**Subject: Parker Pointe, Black Rock Coffee, Site Plan Review Comments 04**

The following are responses to comments received from the City of Parker – Development Review Division, dated September 26, 2025, regarding the Site Plan Review from the City of Parker.

**CDOT REGION 1 10**

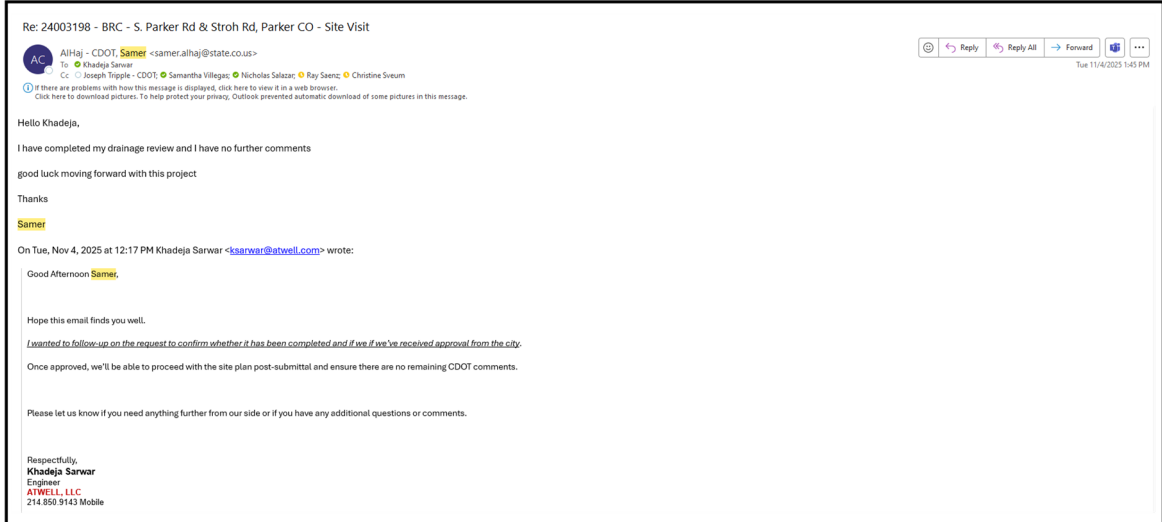
See uploaded CDOT comments.

➤ Acknowledged, please see the snippet below:
